Descriptive Report to Accompany Hydrographic Survey H11939

Project S-N922-RA-08
Grays Harbor, Washington
Approaches to Grays Harbor, Washington
Scale 1:10,000
September 2008
NOAA Ship *Rainier* (s221)
Chief of Party: Captain Donald W. Haines, NOAA

Revisions and Corrections Compiled During Office Processing and Certification

Figure 6: Area of Significant Holiday

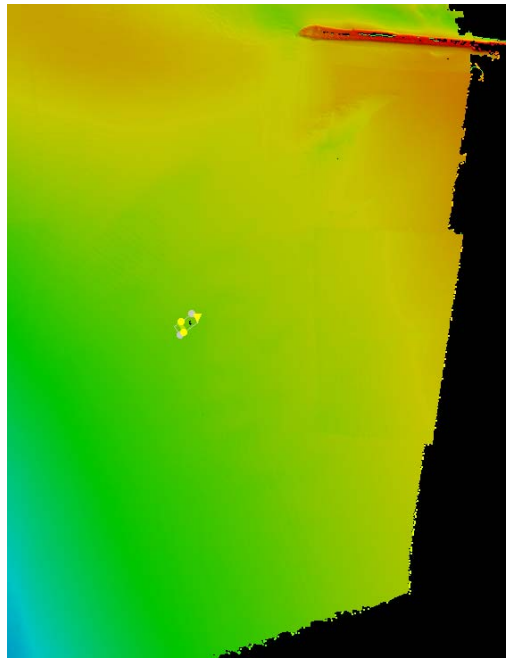
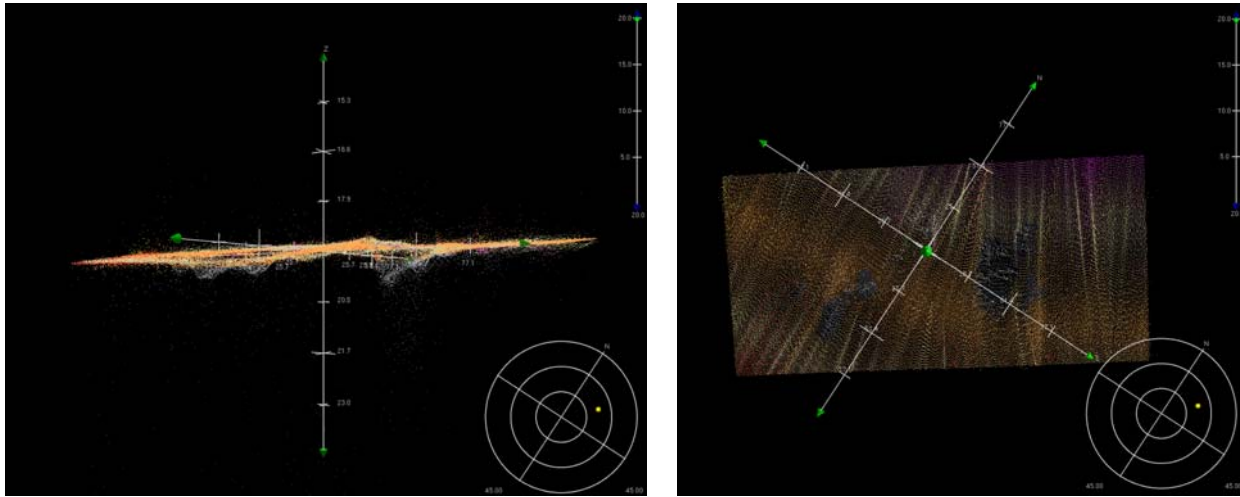
One of the larger holidays occurs on the BASE surface approximately 1.5 NM south of the submerged jetty, as depicted in Figure 6. As seen in the 3D Subset Detail in Figures 7 and 8, the holiday is caused by rejection of erroneous data blowouts. Existing data meet the standard of feature detection and should supersede charted depths.⁸

⁸ Concur.

Figure 11: Survey Soundings overlaid on Chart 18502 in North Jetty Area

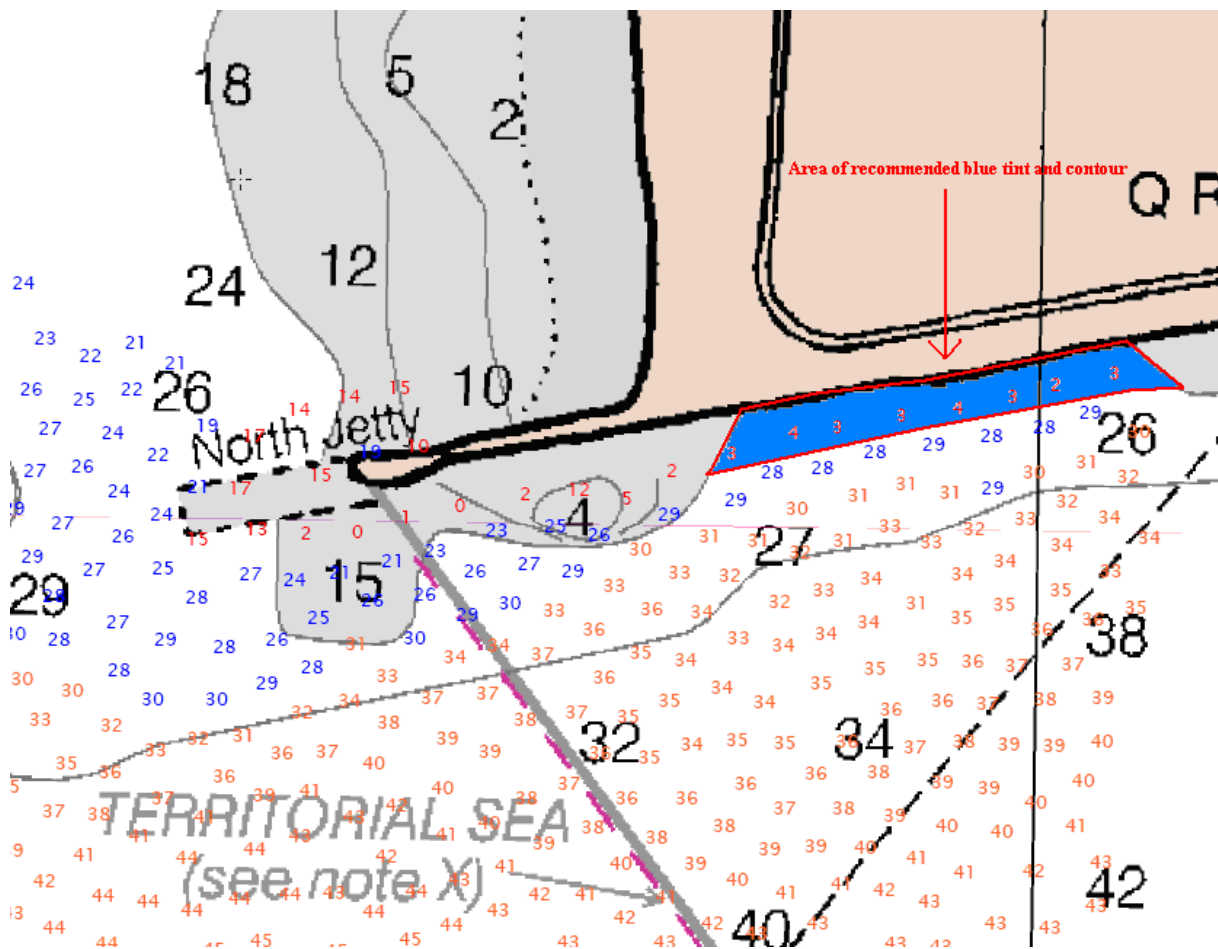
1. The area in the Southwest corner of the sheet entitled “Disposal Area” was confirmed with depths 5 feet deeper than charted from 2002 Survey. The Hydrographer recommends retaining the “Disposal Area” notation on chart and updating soundings as per digital data.¹⁰
2. Depths around AWOIS item 53117 ¹¹(Southern “Submerged Jetty”) are significantly deeper than charted. Further discussion can be found in the AWOIS Investigations section D.1.c.
3. The North Jetty has shoal areas adjacent to the shore that extend further from shore than charted, as depicted in Figure 11. The Hydrographer recommends extending the contour line with blue tint in this area.¹²

¹² Concur.

Figure 12: 45' Soundings in Bar Entrance Channel of Chart 18502

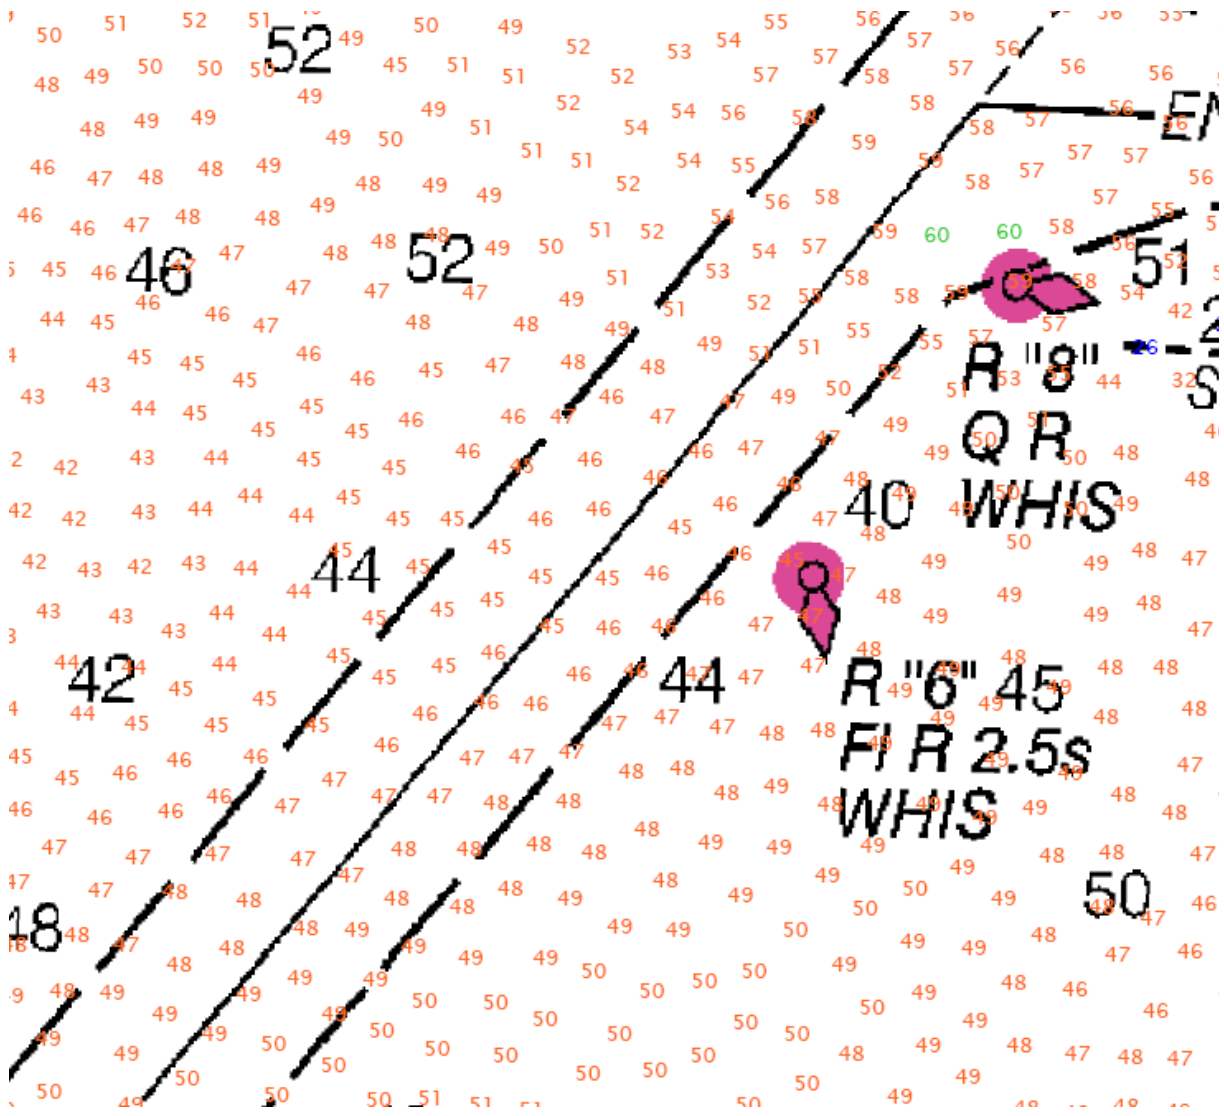
4. Several 45' soundings were noted in the middle half and left outside quarter of the bar channel, as depicted in Figure 12. These soundings are shoaler than tabulated depths, which are 46.7' for the outside quarter and 46.4' for the middle half of channel. On 3/27/2009 the Northwest Region Navigation Manager was notified of the shoaler depths. This information was passed on to the US Army Corps of Engineers, who started a dredging project on 4/2/2009, the extents of which cover the above mentioned shoal area. A copy of the correspondence is included in Appendix V, Supplemental Correspondence. The Hydrographer recommends updating the tabulated depths from the U.S. Army Corps of Engineers post dredge survey, expected after completion of the dredging assignment.¹³

¹³ Concur. Records of correspondence are appended to this report.

Figure 13: Buoy G "3" on Chart 18502 and overlaid 18500

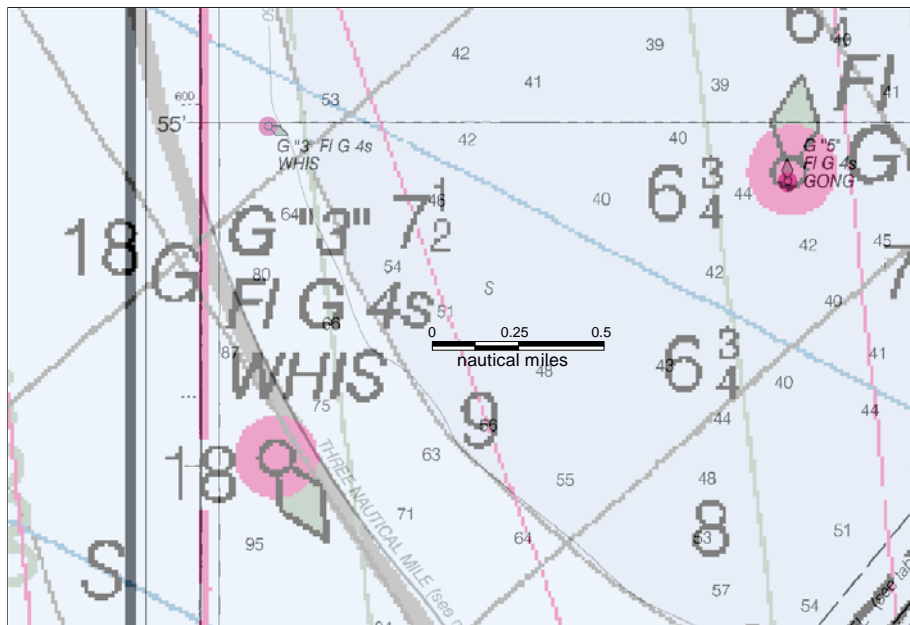
Discrepancies between the charted and surveyed positions were found for the following ATON. The Green "3" Buoy denoting the entrance to the harbor is noted in the incorrect position on chart 18500. Chart 18502 has the accurate position, approximately 1.1 NM north of the charted 18500 G "3" Buoy (see Figure 13). The discrepancy has been reported and corrected in the District 13 Local Notice to Mariners, week 39/08.²²

²² Use latest ATONIS information.

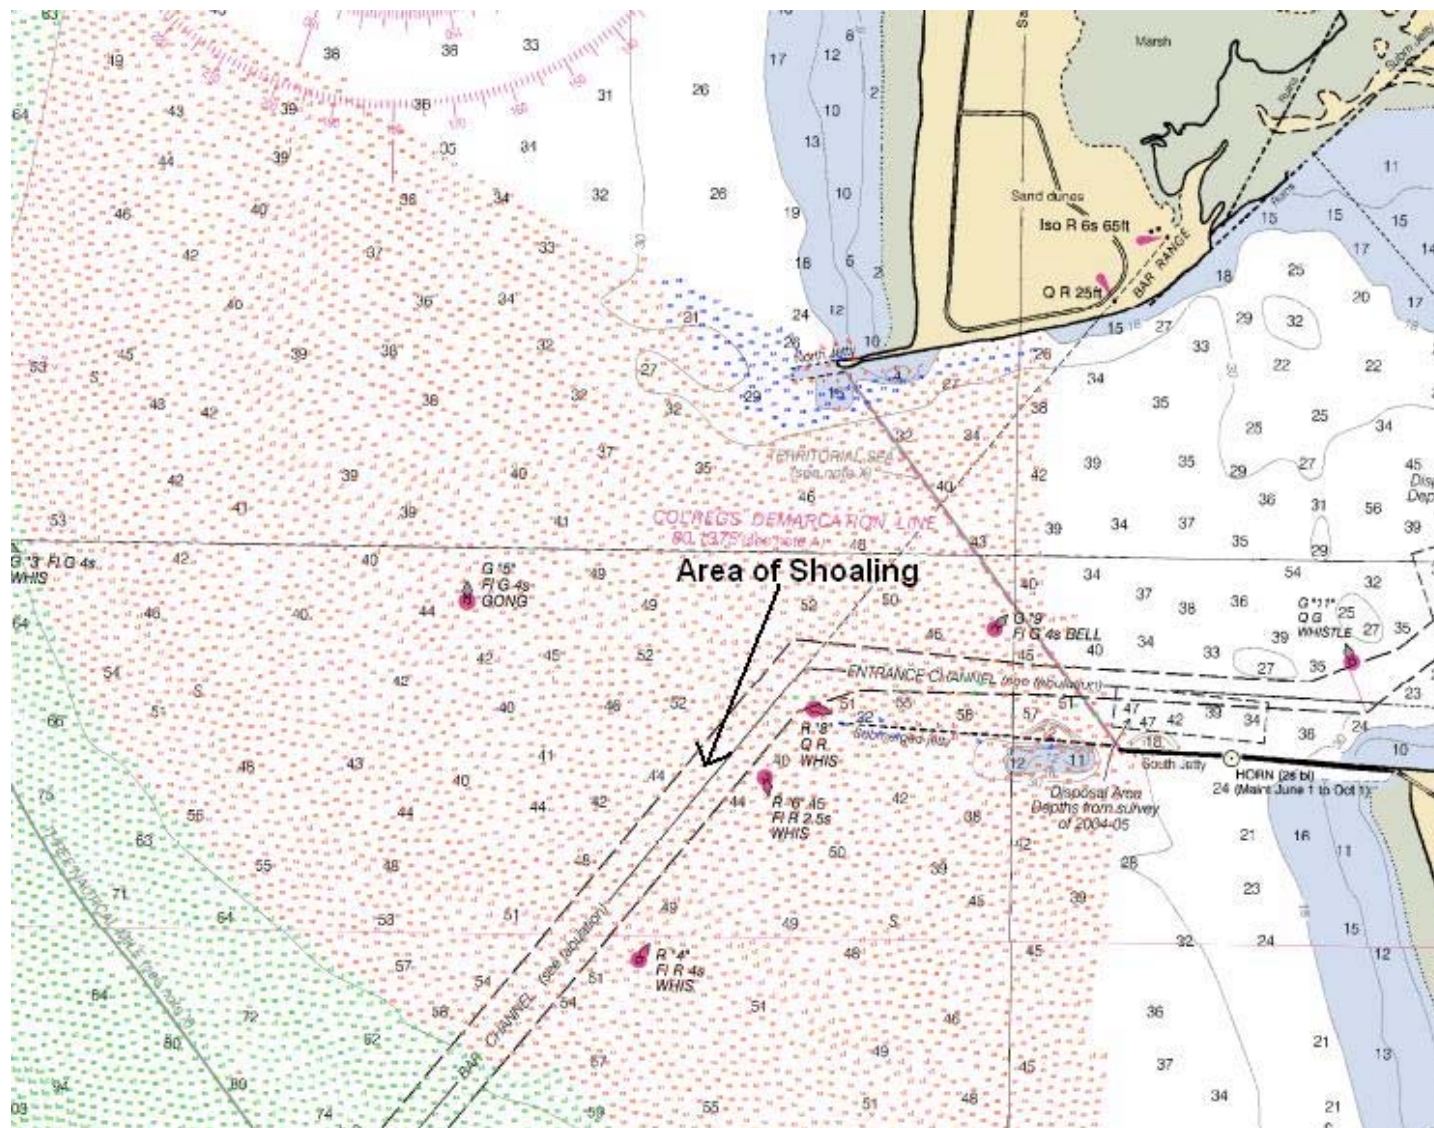
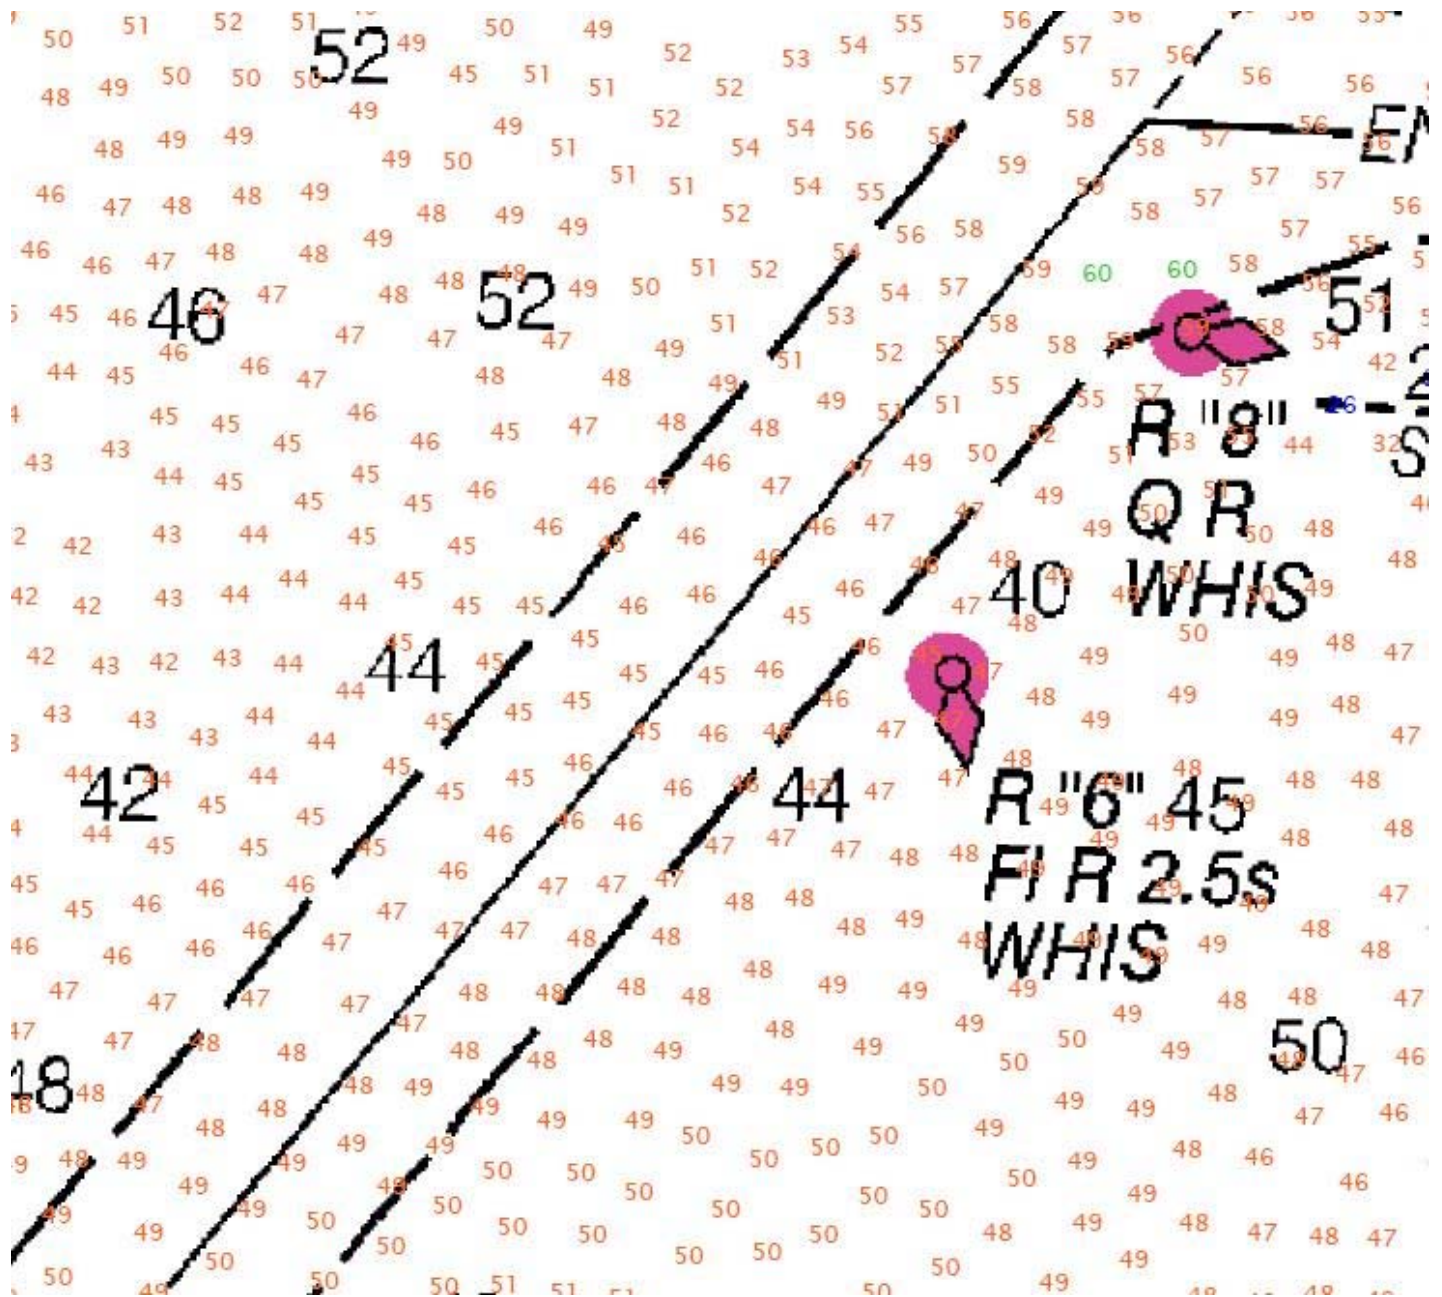
Following the analysis of data in survey H11939 (Approaches to Gray's Harbor) there were soundings noted on the plot that were shoaler than tabulated depths. The data were examined and found to be accurate. Please forward this information as appropriate to the U.S. Army Corps of Engineers and any local controlling authorities.

Attached are two depictions of the soundings. One is a general area depiction from the plot, and the other is a detailed view of the 45' soundings within an area of the channel with a 46.7' tabulated depth.

Our Gov't Hopper dredge ESSAYONS will start O&M dredging at Grays Harbor tomorrow. The dredging assignment includes dredging in the bar shoal area reported in your email. Will be getting a post dredge of the area in about three weeks.
